Service Bulletin

Subject: Information on Replacing Half Shaft Fasteners with Revised Parts

Brand:	Model:	Model Year:		VIN:		Engine:	Transmission:
		from	to	from	to		
Cadillac	ATS-V	2016	2017			LF3, LF4, LT1, LT4	
	CTS-V	2015	2017				
Chevrolet	Camaro	2016	2017

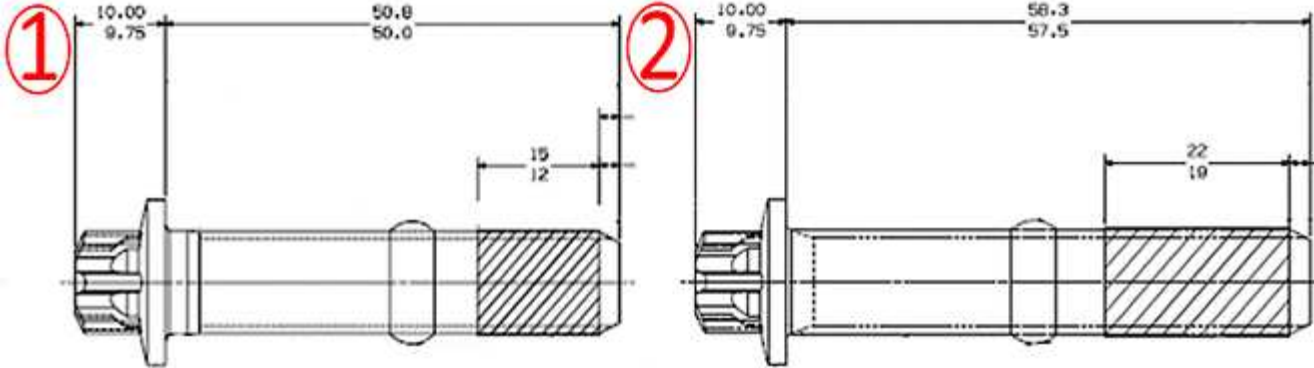
This bulletin advises the Service Technician of new retainer assemblies that are required to be installed during any repair that requires the half shaft bolts to be removed or replaced.

- Three retainer assemblies required per half-shaft.
 - Each retainer assembly consist of 2 longer length bolts (1), 2 lock washers (2) and 1 retainer (3).
 - Where applicable, each axle assembly uses 3 retainer assemblies per side.

- Replacement of **all** retainer assemblies are required during repair.

- Remove and discard retainer assemblies.
- Install new retainer assemblies.
 - Torque bolts to proper torque specifications. Refer to Fastener Specifications in SI.

Service stock half shafts may include POA retainer assemblies that have the shorter bolt (1), these assemblies may require to be exchanged with new retainer assemblies that have the longer bolts (2).

- The new half shaft bolts must be removed, measured and discarded if the length is incorrect.
